CEPC TDRrd ECAL Updates

Yong Liu (IHEP) for the CEPC TDRrd ECAL team CEPC Reference Detector TDR Weekly Meeting December 17, 2024

Preliminary report of IDRC Review: ECAL part (1)

SiPM response to BGO scintillation

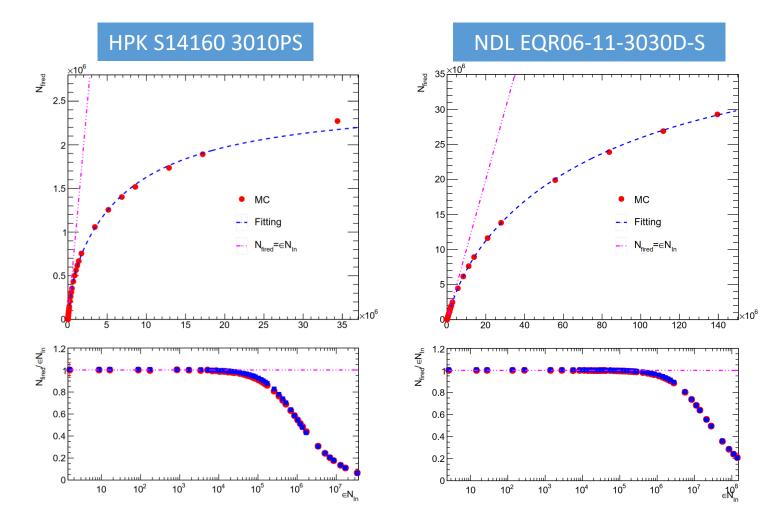
• Feedback to "SiPM dynamic range and linearity needs specification."

A Monte Carlo model to simulate the SiPM response to BGO(40x40x1cm) scintillation light. The model includes both BGO and SiPM properties.

We would need to formulate specifications based on these studies

Crystal calorimeter prototype in beamtests

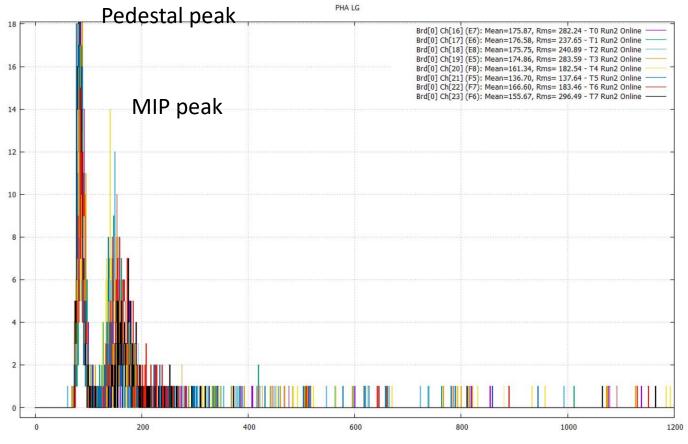
• The noise levels of the ECal including SiPMs and readout electronics

The crystal calorimeter prototype used commercially available ASICs. The S/N ratio is promising and barely noises besides pedestals

We would need to discuss with electronics team for further evaluation with custom-made designed ASIC in planning
